Mercury Diesel 4.2L V8 Tier 3 Exhaust Manifolds Replacement

Models Covered	Serial Numbers Affected
4.2L V8 Tier 3	CMC000200 and up

A letter will be sent to every registered owner of an affected Mercury Diesel engine. The letter will reference Mercury Diesel Service Bulletin 2018-61 and will advise the owner to contact their selling dealer or a Mercury Diesel authorized dealer for repair. A copy of the customer letter is included with this service bulletin for your reference.

Exhaust manifold that does not require replacement

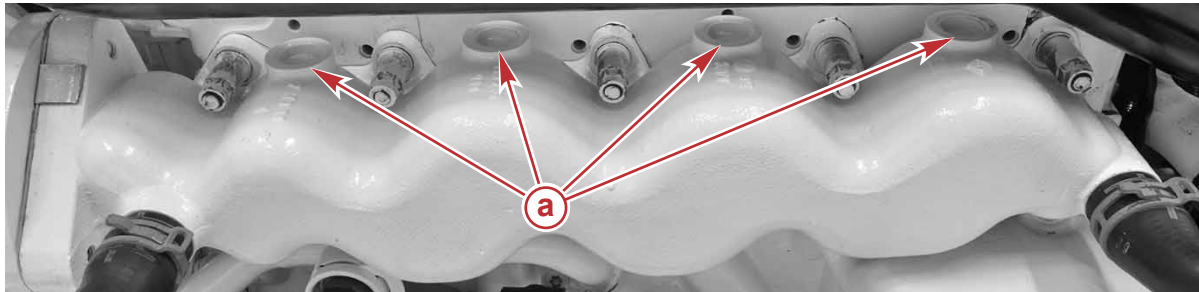
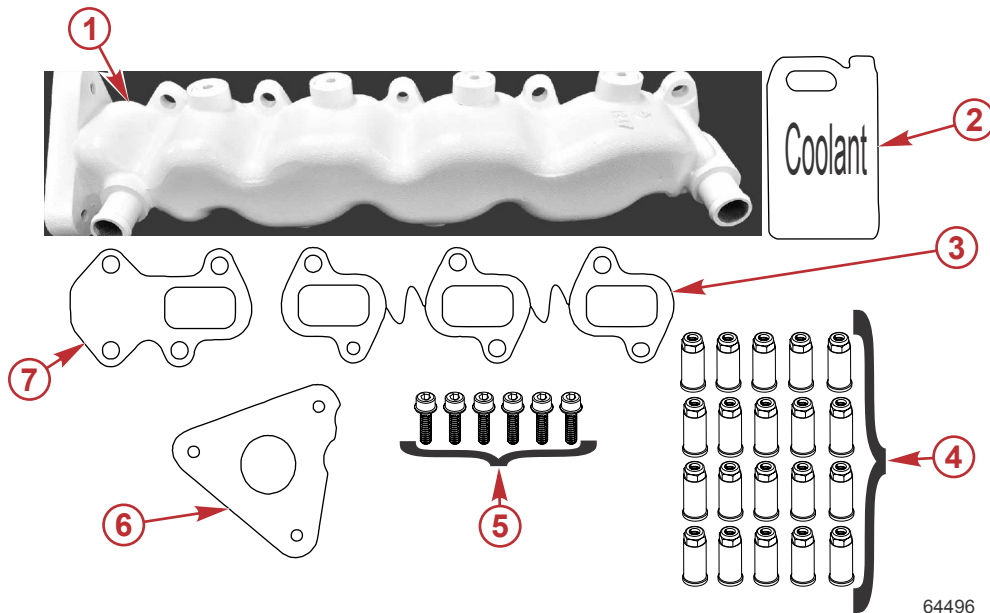
Mercury Diesel has identified a situation whereby internal sections of the exhaust manifold may overheat, which would cause the manifold to crack or allow the cap plugs to be pushed out. The result of either of these failures will cause a very quick loss of engine coolant.

Engines already reworked by the factory will have manifolds with threaded cap plugs and a Mercury part number as shown in the photo below. The exhaust manifold that needs to be replaced will have pressed in cap plugs. The following two images show the visual differences between the two designs.

- a** - Threaded cap plugs (containing an internal hex)
- b** - Mercury part number (8M0128259 or 8M0133046) which is cast into the manifold

a - Pressed in cap plugs (containing a depressed inner diameter)

IMPORTANT: Perform these procedures only if the exhaust manifold (containing the pressed in cap plugs) as described above is installed on the engine. Disregard these procedures if the exhaust manifold (containing the threaded cap plugs) as described above is installed on the engine.
